# **MHCLG Consultation on Part L and Part F 2020 and the Future Homes Standard**

## **CIBSE Response**

7<sup>th</sup> February 2020

### 3.2 Evidence provided by Greengauge for the West of England Local Authorities

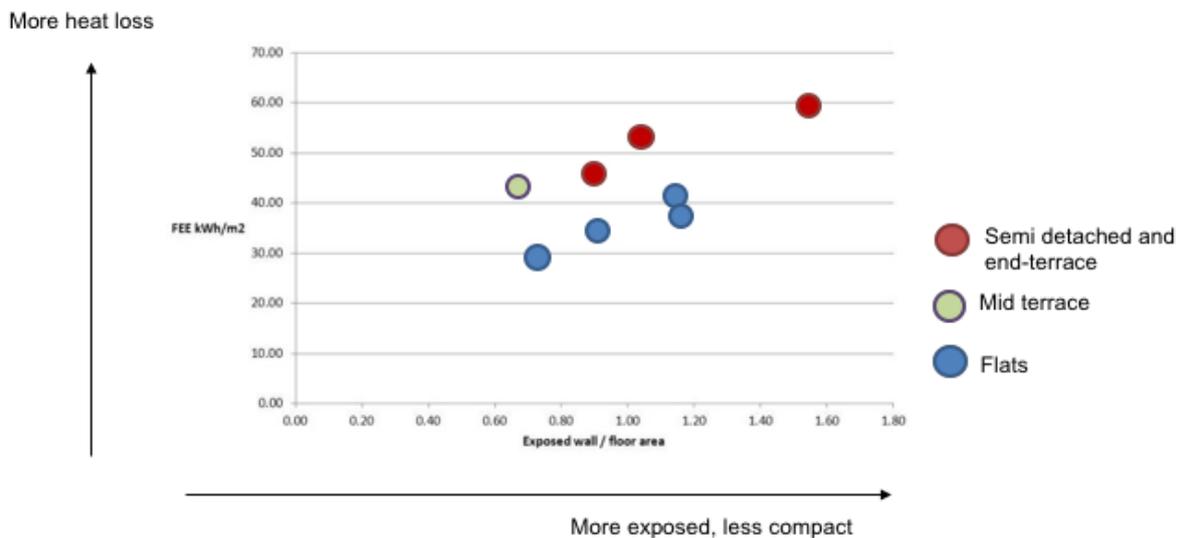
Based on modelling of one semi-detached house, and one mid-floor flat:

“The Part L 2020 standard could allow worse fabric than is currently allowed under Part L 2013, since the FHS consultation proposes to remove the TFEE.

Figure 2: Illustration of disconnect between EPC bands and actual energy consumption in the domestic sector: Energy intensity of 410 homes across a local authority in England, by ECP rating. Each bar represents a single dwelling's energy intensity over the course of a year (credit: Etude)

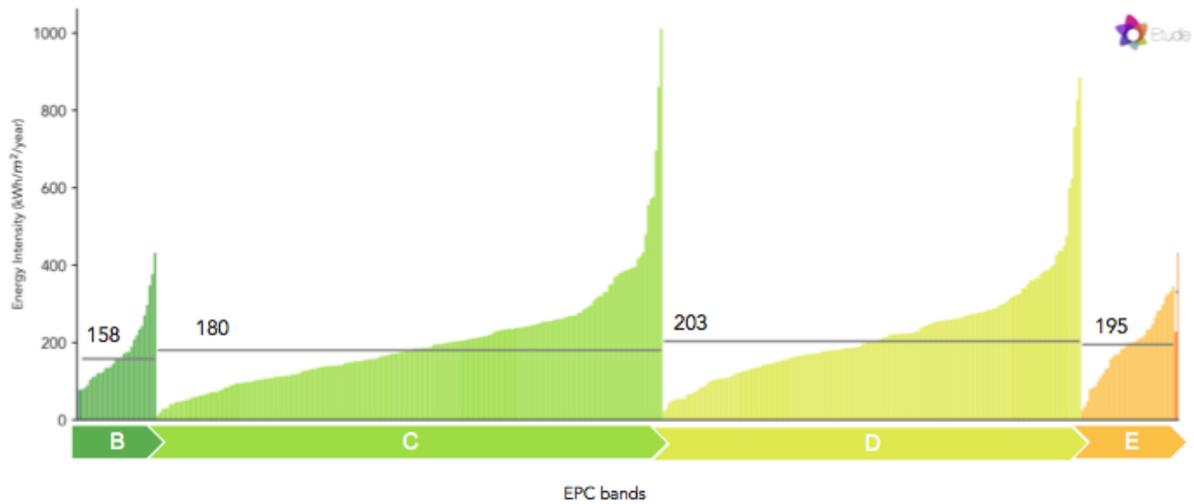
## Appendix 5 – The approach needs to change: there is a very poor relationship between EPC ratings and actual energy consumption

Figure 1 - Results of Etude PHPP modelling for a typical semi-detached dwelling: Space heat demand must be lower to deliver net zero carbon homes.

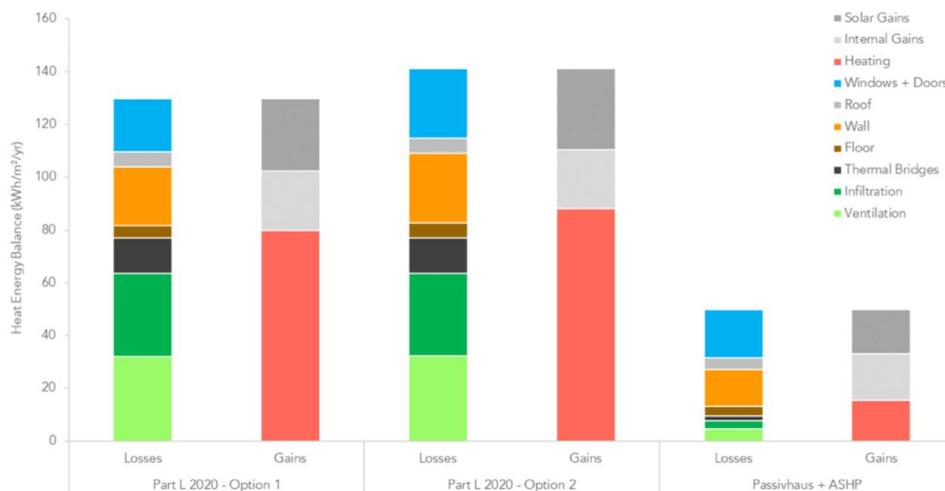
This shows that airtightness and ventilation losses represent a significant proportion of heating demand, and the key areas where improvements would deliver energy and carbon savings
